Q&A with Planner re Oceano Hotel Wedding Building 11/28 – 12/8/14

Exhibit "B"
Deed Restriction
"No Build Zone"

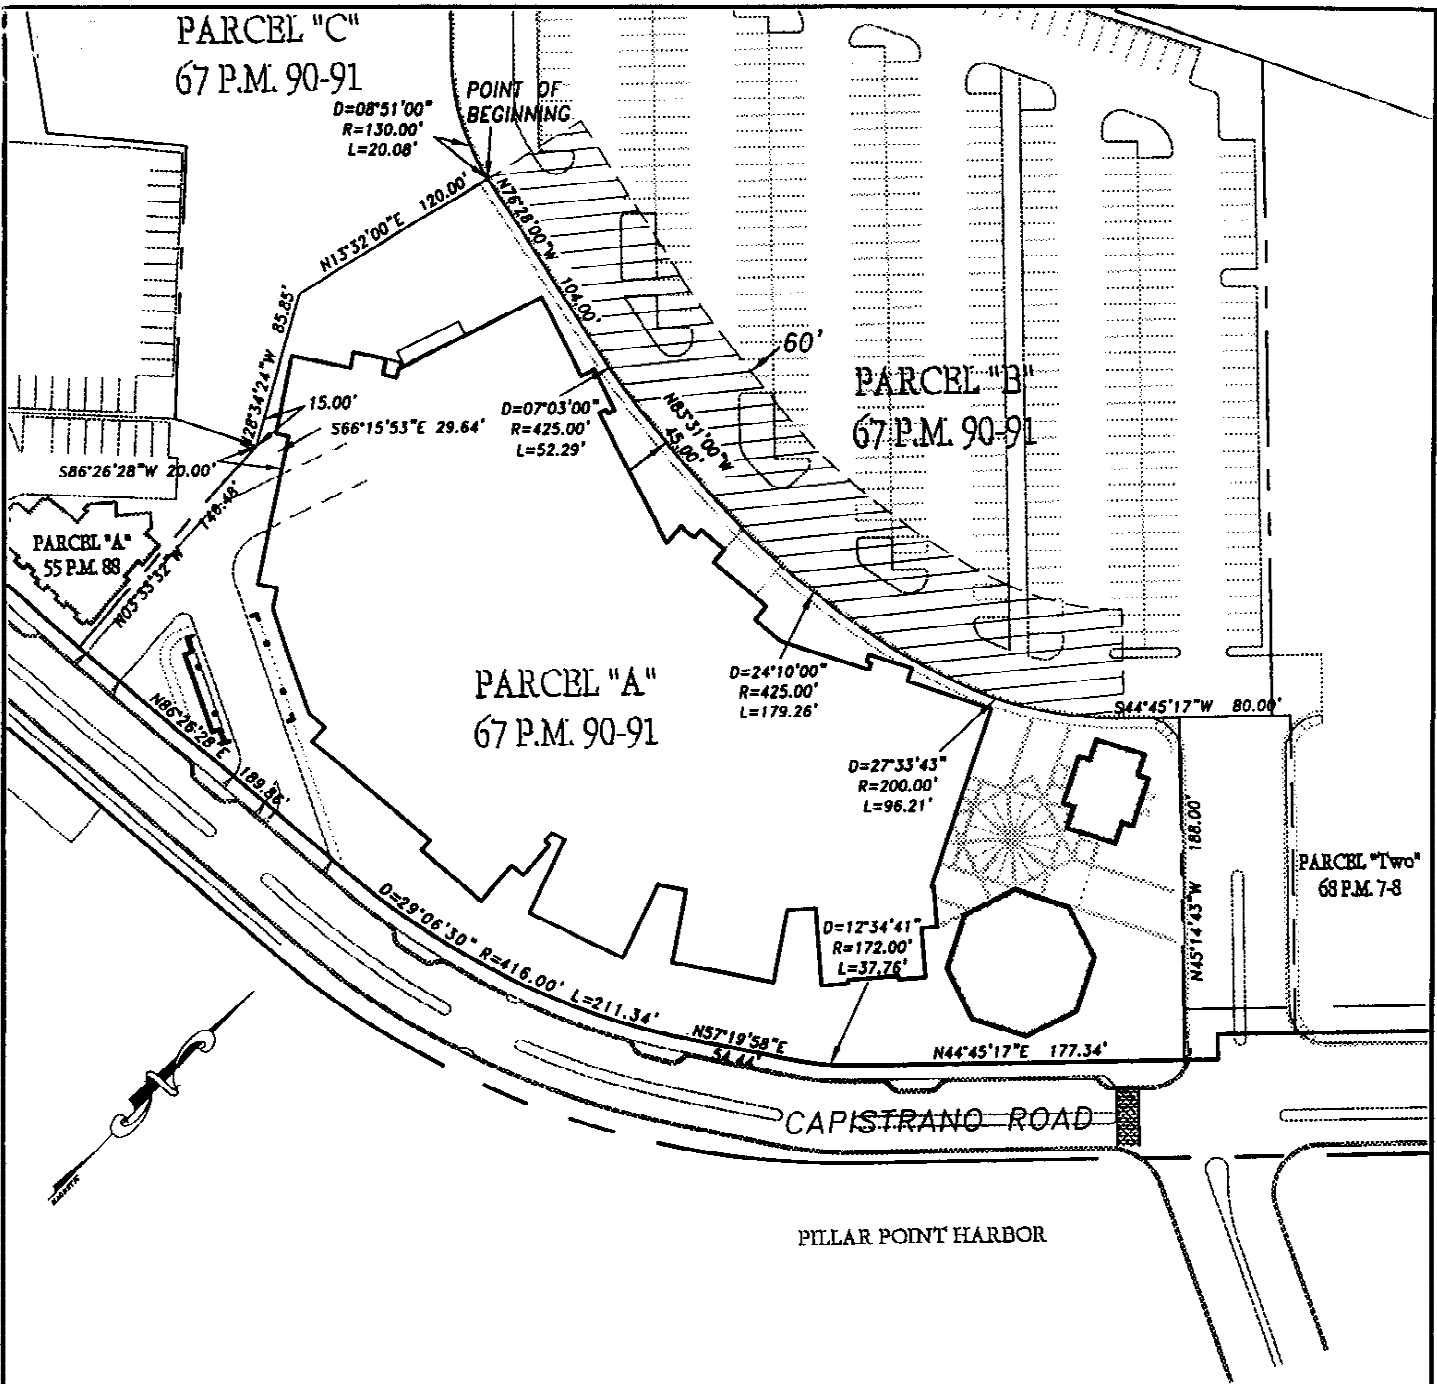
Q: I noticed this notation at the online permit site for BLD2000-01630 (hotel): "6/16/04 GPF - Received a copy of recorded Deed Restriction for the "No-Build-Zone". NO EXCEPTION TAKEN". How can I find out where this is no-build zone is?

A: (1/8/15) I've found a recorded copy of the No Built Deed Restriction - see attached. It's a 60' strip of land on their parking lot parcel - 60' from hotel/shops building. Now that it's been found, I will make note of it and scan a copy of the recorded doc into our permit system for future reference.
